LINOTYPE IMPROVEMENT INFORMATION SHEET

NO. 266

ASSEMBLER (ASSEMBLED) PROVIDED WITH OILITE BEARINGS

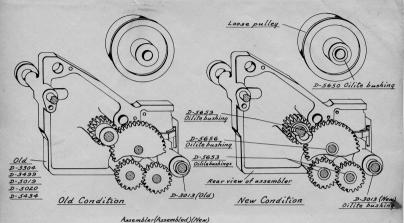
Oilite bearings have been added at the various places on the assembler which have heretofore required manual lubrication. This will eliminate the necessity of oiling, thus preventing the possibility of oil coming in contact with the assembler driving belt or matrices.

Can be applied to outstanding models by substituting new assembler (assembled) as part number designates.
